SUNDRY NOTICES AND REPORTS ON WELLS

WELL	Geronimo Federal #6	FIELD	Geronimo (Delaware)	CO, ST	Lea County, NM.
☐ PRESENT COMPLETION		☒ RECOMMENDED COMPLETION		API# 30-025-31376

Permanent Abandonment of Federal Wells
Conditions of Approval

WELL COMPLETION SKETCH

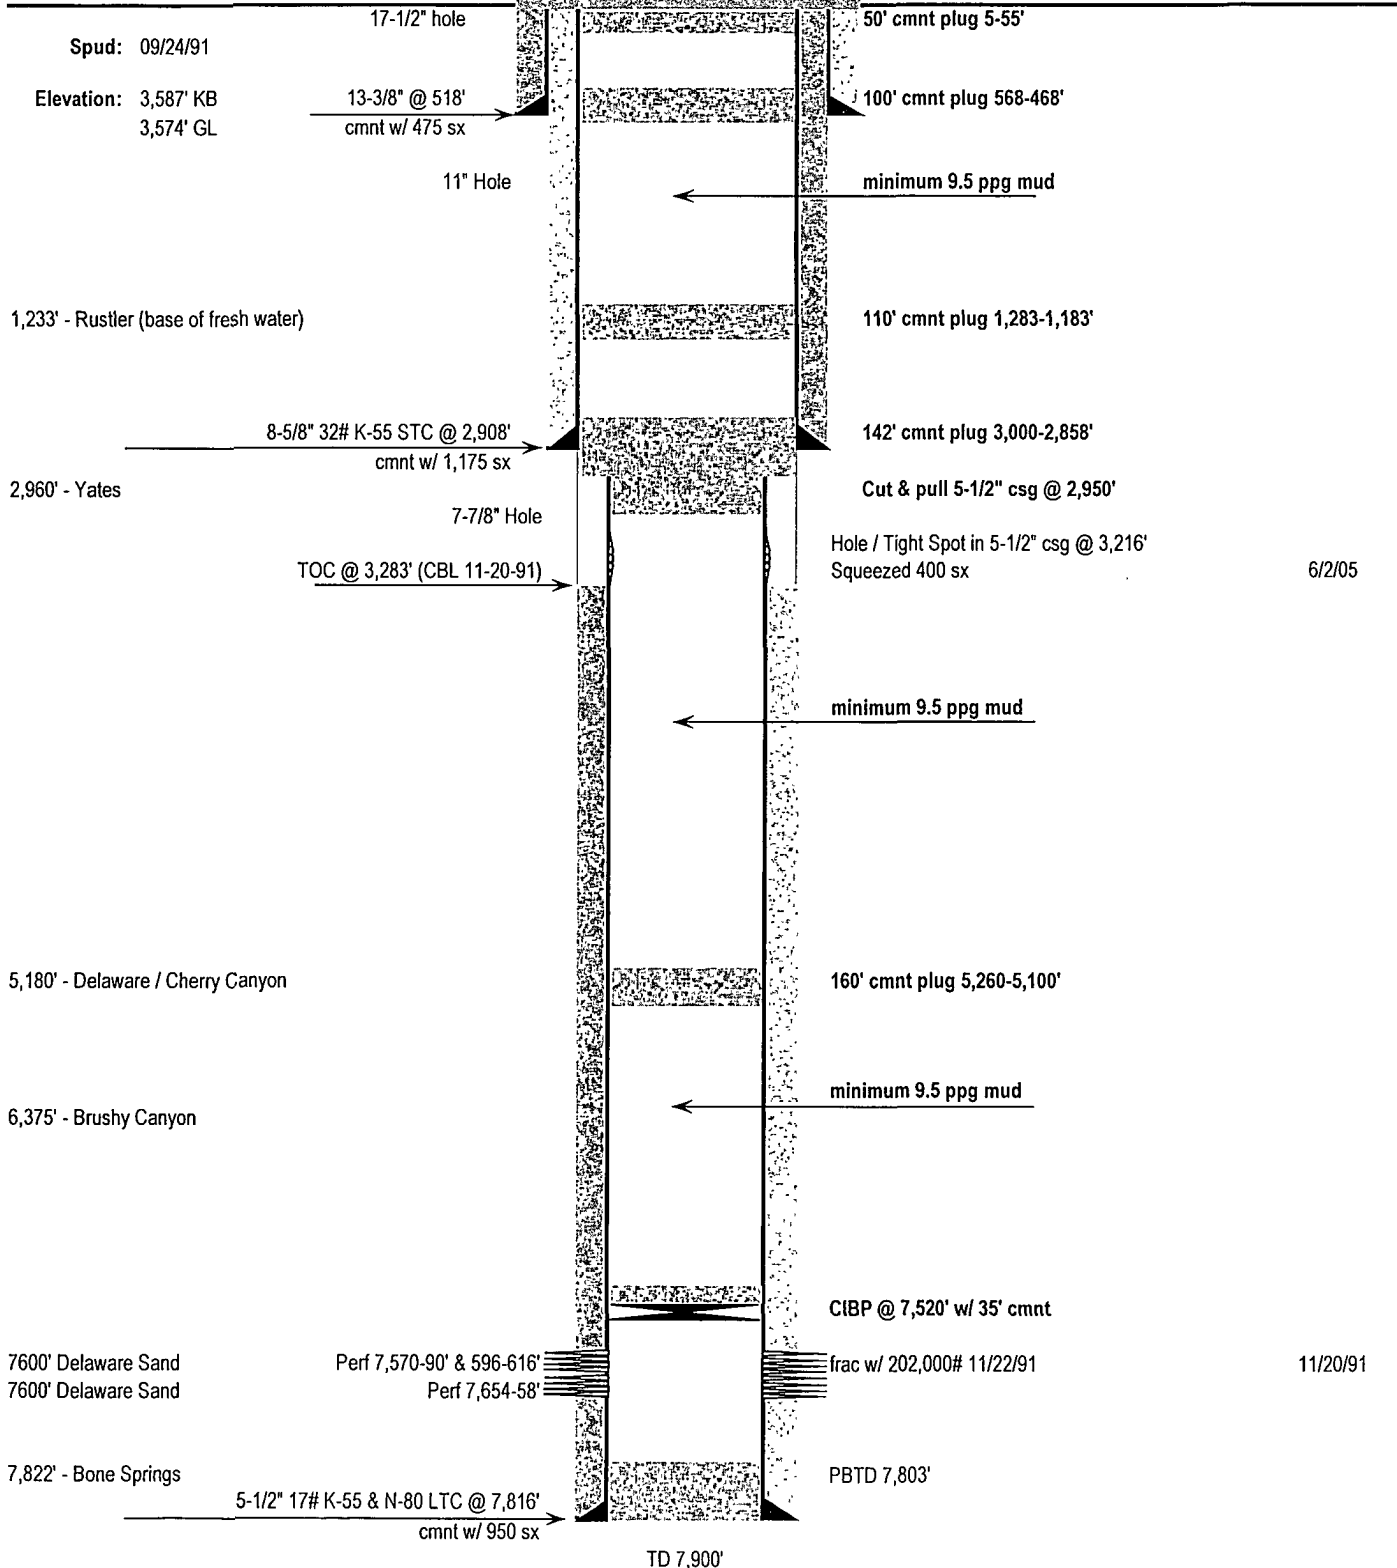
Set CIBP @ 7520' w/35' cmt on top

Set 160' cmt plug 5260' - 5100'

Cut and pull 5 1/2" csg @ 2950'

Set 442' cmt plug 3000' - 2858'

Set 110' cmt plug 1283' - 1183' (base of fresh water)

Set 100' cmt plug 568' - 468'

Set 50' cmt plug 55' - 5'

Set CIBP @ 7520' w/35' cmt on top w/dump bail or spot 25sx plug
Set 160' cmt plug 5260' - 5100'
Cut and pull 5 1/2" csg @ 2950'
Set 250' cmt plug 3000' - 2750' WOC & Tag
Set 110' cmt plug 1400' - 1290' (base of fresh water) WOC & Tag
Set 100' cmt plug 568' - 468' WOC & Tag
Set 50' cmt plug 55' - 5'
Place steel marker 4' above ground level in cmt
Permanently place operator name, lease name, well number and location (Unit, Section, Township and Range) into marker's metal
Reclaim location - Ground level dry hole marker required
